M9537A-02

Modification Recommended Service Note

M9537A AXIe High Performance Embedded Controller

Embedded Controller Encountered Hang Up or Blue Screen during Operating System Recovery

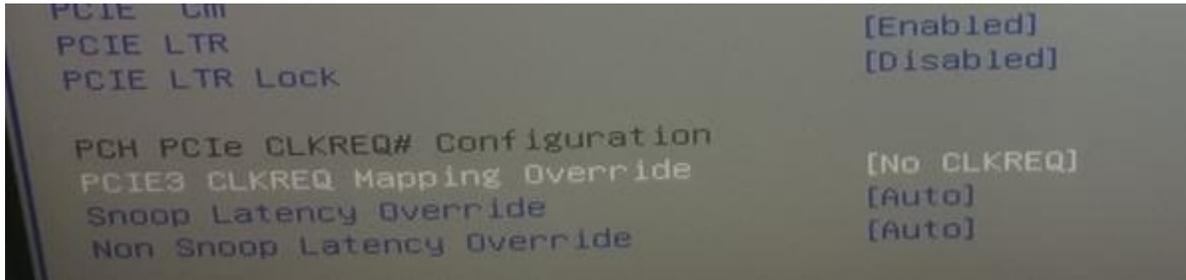
Before performing the OS recovery, disable the BIOS clock request settings to prevent the hang up or blue screen issues shown above. Follow the steps below to disable the BIOS clock request settings.

1. Power on or reboot your M9537A controller.
2. Press the <Delete> key when the controller beeps. This should be concurrent with the main startup screen. The BIOS setup program loads after a short delay.
3. At the main BIOS setup menu screen, select "Advanced" tab.
4. At the Advanced menu screen, select "PCI and PCIe" then press <Enter> key.
5. At the PCI Devices Common Settings menu screen, select "PCI Express Configuration" then

- At the PCI Express Configuration menu screen, select “PCI Express Root Port 3” then press <Enter> key.
- At the next menu screen, select “PCIE3 CLKREQ Mapping Override” then press <Enter> key.
- At the popup menu screen, choose “No CLKREQ” then press <Enter> key. This will change the setting to “No CLKREQ “. Press <ESC> key.
